JRPP No:	2015SYE117 – 101-111 Willoughby Road and a portion of Zig Zag Lane, Crows Nest
DA No:	DA 327/2015
PROPOSED DEVELOPMENT:	Construction of a 4-6 storey mixed use building, including supermarket, public plaza and public car park
APPLICANT:	Coles Group Property Developments Pty Ltd
OWNER(S):	Coles Group Property Developments Pty Ltd & North Sydney Council
REPORT BY:	Kerry Gordon – Kerry Gordon Planning Services On behalf of North Sydney Council

Assessment Report and Recommendation

APPLICATION No: DA327/2015

PROPOSAL: Construction of a 4-6 storey mixed use building, including supermarket, public plaza and public car park

Height

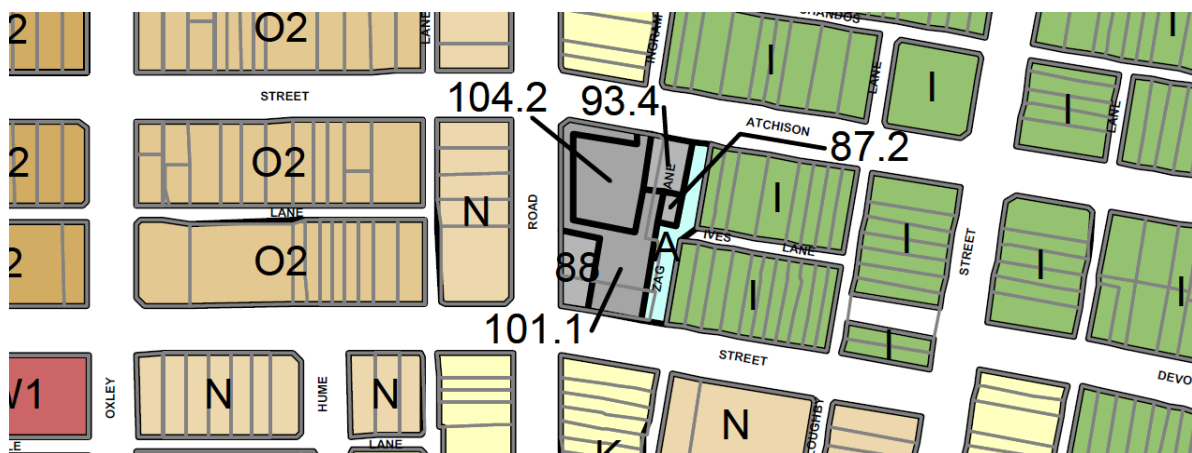
Clause 4.3 sets a variable maximum height for the subject site as shown below, with the height control varying from RL 87.2 adjoining Zig Zag Lane to RL 104.2 towards the north-western corner of the site, with the pale blue portion (Zig Zag Lane) having a maximum 1m height.

- All breaches generally relate to the lift/stair overruns and ancillary elements for the improvement and use of communal areas.
- The breaches were foreshadowed in the Planning Proposal for the site that varied the height control and this was acknowledged in Council's report.

- Compliance with the height control is unnecessary and unreasonable in this instance as the proposal satisfies the objectives of the control.
- The objectives are satisfied because the development is consistent with the anticipated built form established for the site with the development broken into two elements, with the bulk of the development setback from the edge to reduce the perceived bulk of the building. This is consistent with the built form considered appropriate in the Planning Proposal and identified in a height form in the height controls for the site.

The reasons given to support the variation of the height control have been assessed in accordance with the requirements outlined in *Four2Five Pty Ltd v Ashfield Council* [2015] NSWLEC 1009 in relation to clause 4.6 requests, as against the requirements of clause 4.6 and the objectives of the building height control and are concurred with and it is considered that there are sufficient environmental planning grounds to warrant variation of the control in this instance. As such it is considered that the clause 4.6 variation request is well-founded and can be supported.
